Subject: Final Supplemental Response to NRC Request for Additional Information on the Hematite Decommissioning Plan and Related Revision to a Pending License Amendment Request (License No. SNM-00033, Docket No. 070-00036)

Final Supplemental Response to NRC Requests for Additional Information on Decommissioning Plan Chapter 1

Figure 3. Bedrock Topography in the Vicinity of the Hematite Site (z-axis is ft above mean sea level, x-axis and y-axis are standard easting and northing grids)

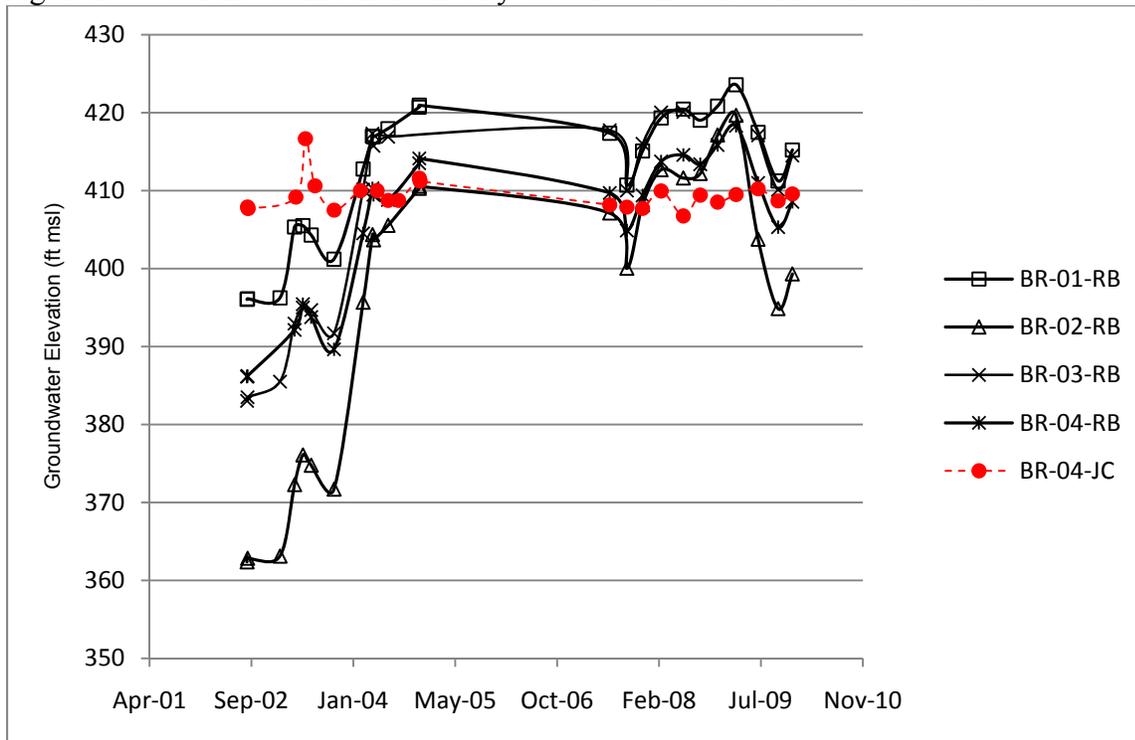
3-7	(c) “...The increasing height of the bedrock to the north and northwest would preclude general flow direction of north or northwest”.	<p>Need to discuss the basis for this conclusion.</p> <p>The hydraulic heads measured from monitoring wells appear to indicate a possibility that groundwater in the Jefferson-Cotter HSU may locally flow towards north/northwest direction at the NW site boundary area of site buildings. The Discussion Points provided address the flow in general terms. Are there site or local specific conditions that show otherwise?</p>	<p>The Jefferson City-Cotter HSU is a component of the Ozark aquifer on the Salem Plateau. Imes and Emmett (1994) and Miller and Vandike (1997) indicate that groundwater within the Ozark aquifer [which contains the Cotter, Jefferson City and Roubidoux Formations] occurs under unconfined conditions with groundwater flow occurring from upland areas toward valleys where it discharges as stream base flow. In the vicinity of the Hematite Site, groundwater within the Jefferson City – Cotter HSU appears to be unconfined. However, the results of a variety of hydraulic testing and potentiometric measurements for the Roubidoux HSU suggest that the deeper aquifer is confined. (Source: “Radionuclide Activity in Bedrock Groundwater at Westinghouse Hematite Facility, Hematite, Missouri,” which was provided to NRC via Westinghouse letter HEM-09-133, dated 11/10/2009.)</p> <p>The Hematite facility is located in the Joachim Creek valley with groundwater flow occurring from bedrock formations comprising the valley sides and moving toward Joachim Creek. The facility and Joachim Creek are shown in yellow in the attached Figure 3. This figure is intended to show the relative steepness of the valley within which the facility is located. The local site specific conditions of hills to the northwest of the site and the gaining Joachim Creek to the southeast of the site suggest that the upper bedrock layer (Jefferson City-Cotter) slopes towards the southeast, with groundwater flowing in that direction. As seen in the groundwater flow maps provided in the response to RAI 4-13, the water level data at PZ-04 only intermittently appears to “mound,” and create an appearance of flow to the northwest. This “mounding” is considered an anomaly, attributed to local natural geologic and hydrogeologic conditions possibly resulting from a combination of locally confined conditions, a local lack of secondary porosity features such as fractures or joints, and massive, fine-grained bedrock lithology in the screened interval in each well.</p> <p>Imes, J.L. and Emmett, L.F. 1994. <i>Geohydrology of the Ozarks Plateau Aquifer System in Parts of Missouri, Arkansas, Oklahoma, and Kansas</i>, U.S. Geological Survey Professional Paper 1414-D, Regional Aquifer System Analysis- Central Midwest. pp 43-51.</p> <p>Miller, D.E. and Vandike, J.E. 1997. <i>Groundwater Resources of Missouri</i>, Missouri State Water Plan Series Volume II, Missouri Water Resources Report No 46, Missouri Department of Natural Resources, Rolla, Missouri. pg 64.</p>	Westinghouse has provided the requested clarifying information in the Discussion Points. No further action required.

Appendix F. DP Figure 5-5 "Depth of Soil Contamination"

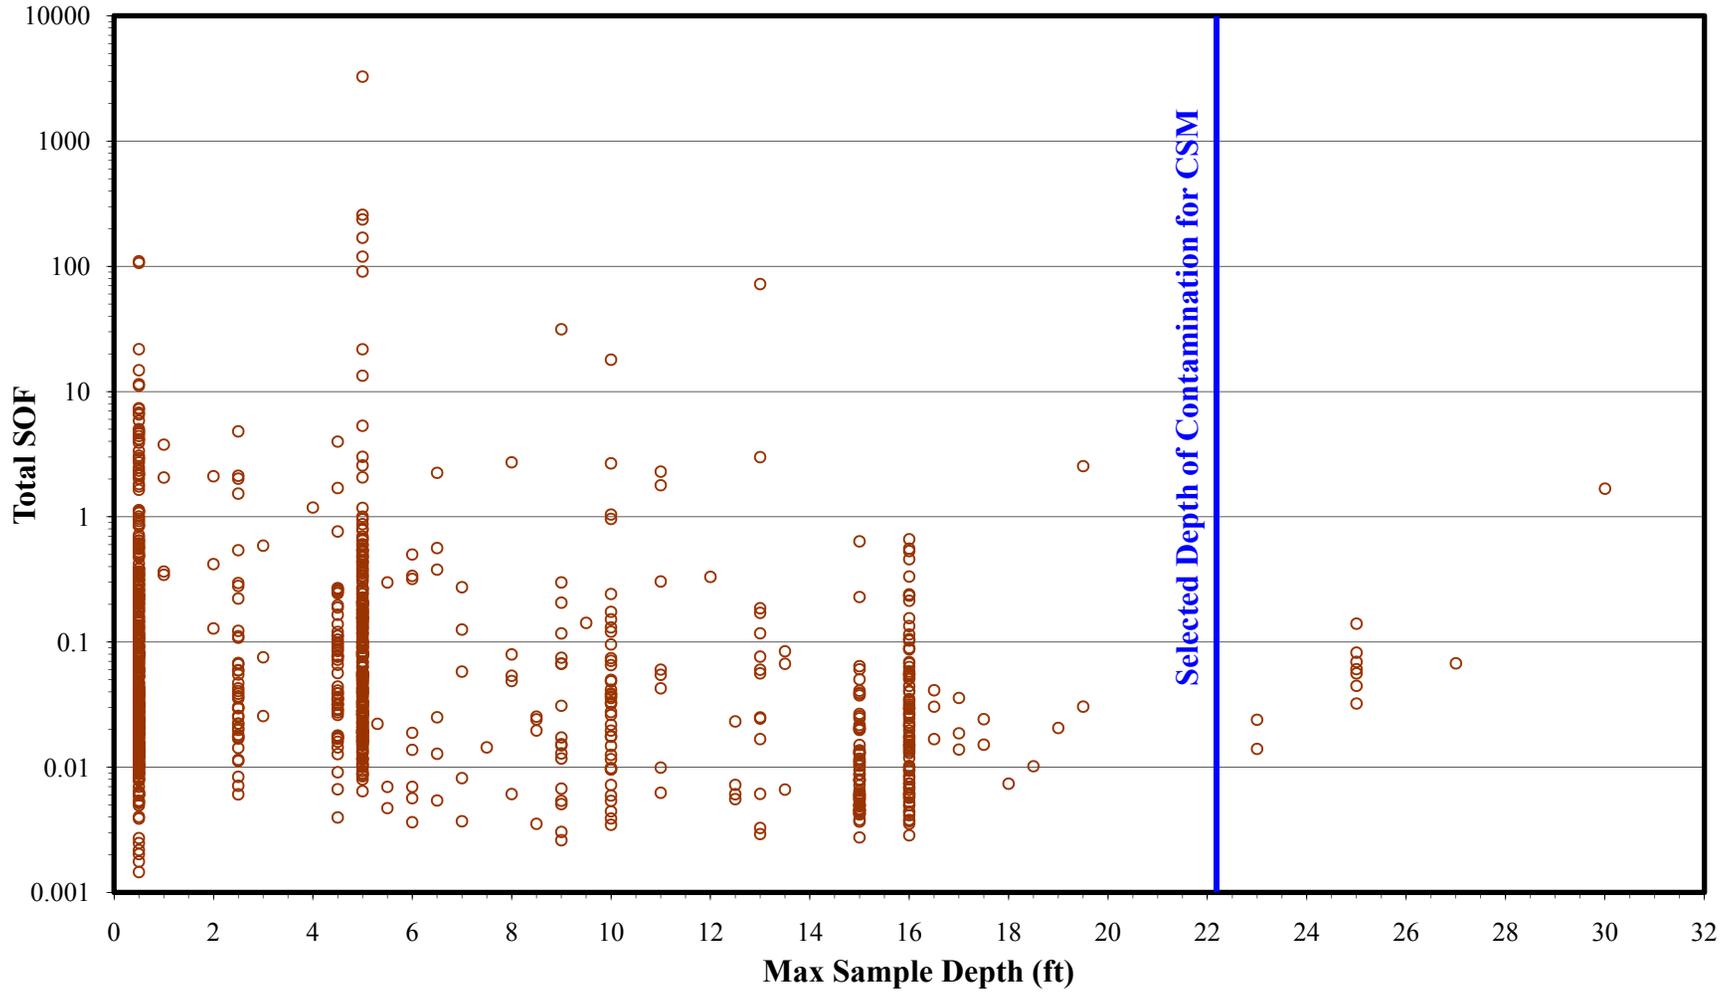
5-3	<p>Westinghouse showed a sensitivity analysis for the Deep DCGLs but did not discuss how the Uniform DCGLs might be impacted by a similar sensitivity analysis.</p>	<ol style="list-style-type: none"> 1. Perform a sensitivity analysis showing how the <i>Uniform</i> Tc-99 DGCLs change with variation in the contaminated zone thickness. 2. Send an updated Figure 5-5. 	<ol style="list-style-type: none"> 1. Westinghouse has performed a sensitivity analysis showing how the Uniform Tc-99 DGCL is affected with variation in the contaminated zone thickness. The sensitivity analysis varied the depth of the contaminated zone from 6.7 meters to 9.1 meters, while adjusting the size of the unsaturated zone so that the sum of the two remained equal to 9.1 meters. The analysis shows that the DCGL is insensitive to the thickness of the contaminated zone. 2. DP Figure 5-5, “Depth of Soil Contamination” has been revised. 	<ol style="list-style-type: none"> 1. Appendix E shows the sensitivity chart resulting from the analysis. 2. Appendix F provides revised DP Figure 5-5, “Depth of Soil Contamination”.

DP Figure 14-14. Conceptual Open Land Survey Units

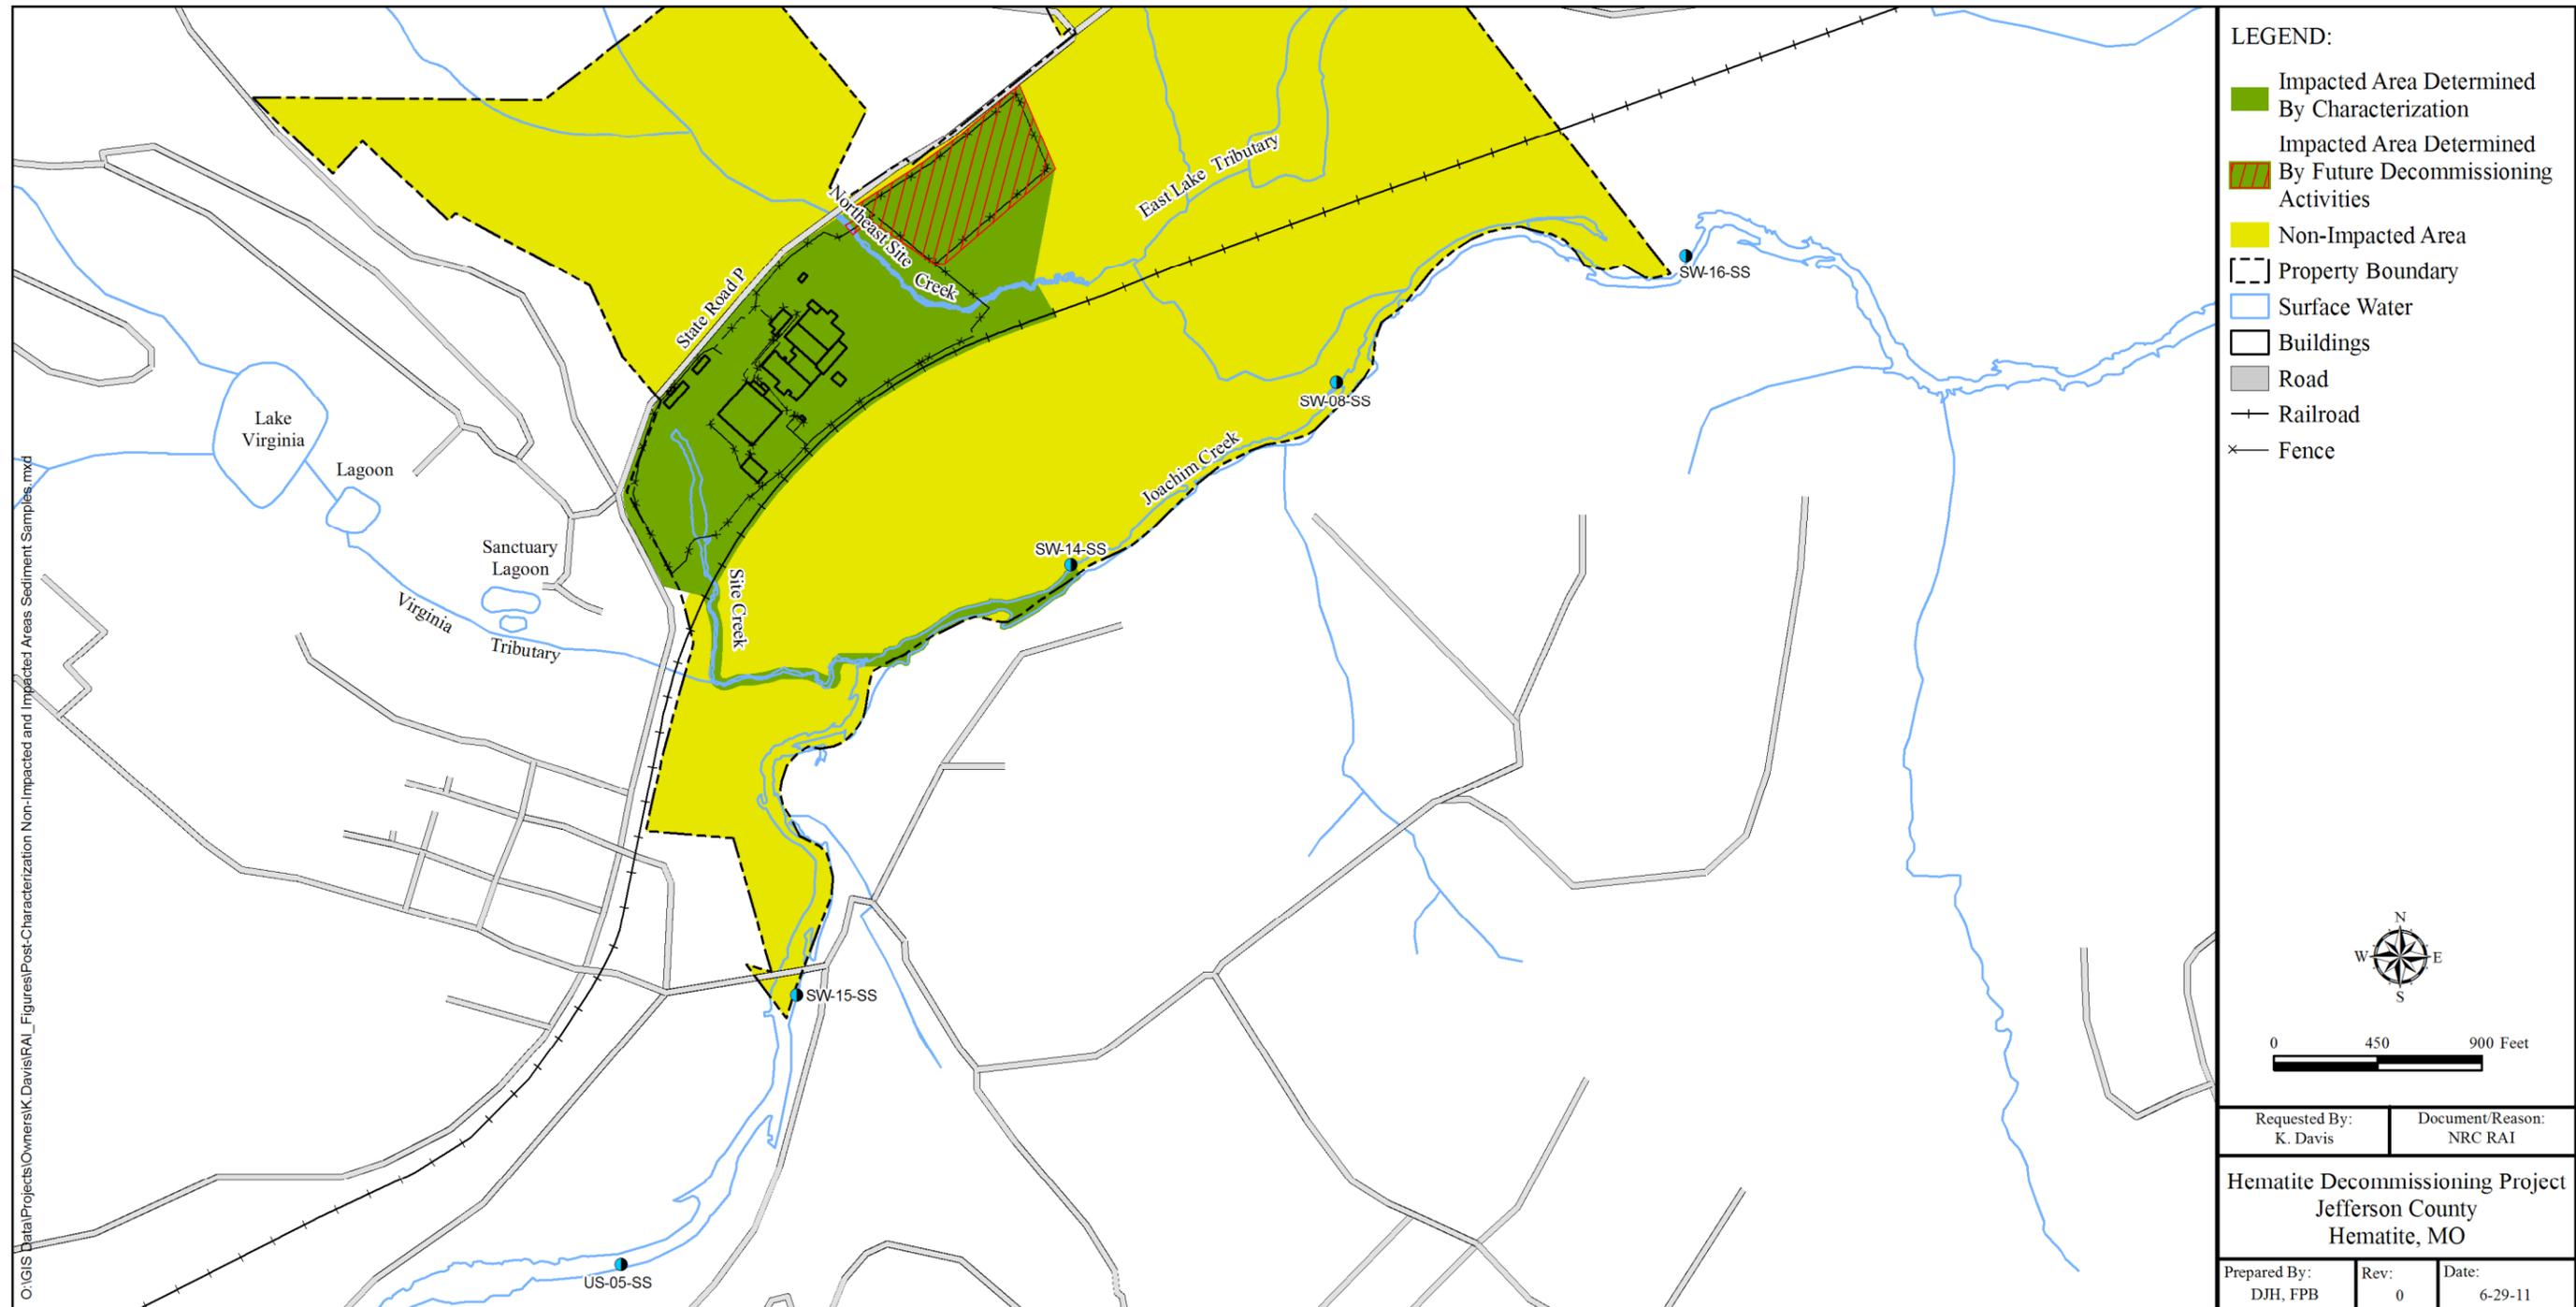
RAI No.	Issues	Path Forward	Discussion Points	Resolution
14-4a	ProUCL tests used to classify areas as non-impacted for certain nuclides and measurements of nuclides for compliance purposes.	Resolution of Chapter 5, RAI No. 1 should address this issue.	This issue is being addressed in the Westinghouse response to Chapter 5 RAI additional question No. 1.	Resolution of NRC comments on DP Chapter 5, RAI No. 1, will also resolve this comment. This comment does not require its own resolution.
14-4b	Failure to categorize areas downstream of Joachim Creek with activities > background as impacted area subject to Class 3 considerations, as a minimum and the failure to extend the impacted area of the creek to the site boundary.	Include downstream areas of Joachim Creek as impacted, Class 3 areas or provide justification for not including them as impacted.	<p>Westinghouse re-evaluated the data in Table 4-12 of the Hematite Radiological Characterization Report (HRCR), HRCR Figure 4-6, and Figure 14-11 from the Decommissioning Plan (DP) and. For convenience, the attached Figure 1 superimposes these two figures together.</p> <p>The review of Joachim Creek for potential impacts starts where the Site Creek enters Joachim Creek. This is because of Site discharges into the Site Pond and the Site Creek. There are no mechanisms for Site impacts to Joachim Creek upstream of where the Site Creek enters Joachim Creek.</p> <p>In reviewing the sample data in HRCR Table 4-12, Westinghouse identified that two sediment/soil samples from Joachim Creek are upstream of where the Site Creek enters Joachim Creek. These two sediment/soil samples are US-05-SS and SW-15-SS. The data for Sample SW-15-SS should be moved to the "Surface – Background Stream Sediment" part of HRCR Table 4-12. Based on these two upstream background values, the downstream sediment/soil sample results do not indicate the presence of residual contamination in the downstream areas of Joachim Creek.</p> <p>Westinghouse understands the potential effect of the Site Creek and Site Pond on Joachim Creek downstream of where the Site Creek enters Joachim Creek. It is for that reason in the HSA Westinghouse provided the following in section 6.2.1.7:</p> <p><i>"Joachim Creek would be classified as non-impacted based on historical and characterization data; however, as described in the Hematite Radiological Characterization Report (Reference 4-4), an impacted (Class 3) buffer zone will be conservatively established along a short distance of the Joachim Creek up to the first radiological characterization sample location east of the confluence of the Site Creek."</i></p> <p>It is also why DP Figure 14-12 shows the impacted area of the site extending from the Site Pond, along the Site Creek, and continuing downstream along Joachim Creek for a short distance.</p>	The data for Sample SW-15-SS will be moved to the "Surface – Background Stream Sediment" part of HRCR Table 4-12.

<p>DP Section 14.2.5 will be revised as follows:</p> <p>Activities with special nuclear materials (SNM) were conducted within an approximately 10-acre Central Tract area of the site. The Central Tract area is bounded by State Road P to the north, the land adjacent to east bank of the Northeast Site Creek, the Union-Pacific Railroad to the south and the Site Pond to the west. Approximately 3.8 acres along the Site Creek downstream to Joachim creek and along Joachim Creek to the location of sample SW-14-SS are considered potentially impacted based on site characterization data; and 7.1 acres to be used as a soil staging area near the Northeast Site Creek are expected to become impacted as result of the decommissioning activities. Additionally, a 20 foot wide area immediately south of the railroad in the central tract, an area west of the Site Pond, and an area between the Northeast site creek and the soil staging area are also considered as impacted (total of about 10.1 acres). The remaining portions of the 228-acre Hematite Site are considered to be non-impacted as illustrated on Figure 14-11.</p> <p>A new DP Section 14.4.4.1.6.6 will be added as follows:</p> <p>14.4.4.1.6.6 Active Rail Line</p> <p>While the boundary of conceptual survey unit LSA-11-02 (Figure 14-14) will encompass the active rail line, the active rail line will not be surveyed or sampled as justified below; surveys and sampling will be limited to the 20 foot section of ground between the southern edge of the active rail line and the southern boundary of this survey unit. The random sampling locations that fall on the active rail line during survey design will be relocated to the southern edge of the railroad bed.</p> <p>This approach for survey and sampling in this newly-defined survey unit is reasonable given the history, nature, and safety considerations of the active rail line. First, the rail has been in existence prior to the initial construction of the facility, thus the potential for subsurface contamination is very small. Second, the</p>	Survey Area Code	Survey Area Description	Survey Unit Code	Survey Unit Description	Initial MARSSIM Class	Area (m ²)		Figure No.	Floor Area	Total Area	LSA-11	East/Southeast Open Land Area	01	Section 1	3	N/A	24,715	14-14			02	Section 2	3	N/A	5,394	14-14
Survey Area Code	Survey Area Description	Survey Unit Code	Survey Unit Description	Initial MARSSIM Class						Area (m ²)			Figure No.																	
					Floor Area	Total Area																								
LSA-11	East/Southeast Open Land Area	01	Section 1	3	N/A	24,715	14-14																							
		02	Section 2	3	N/A	5,394	14-14
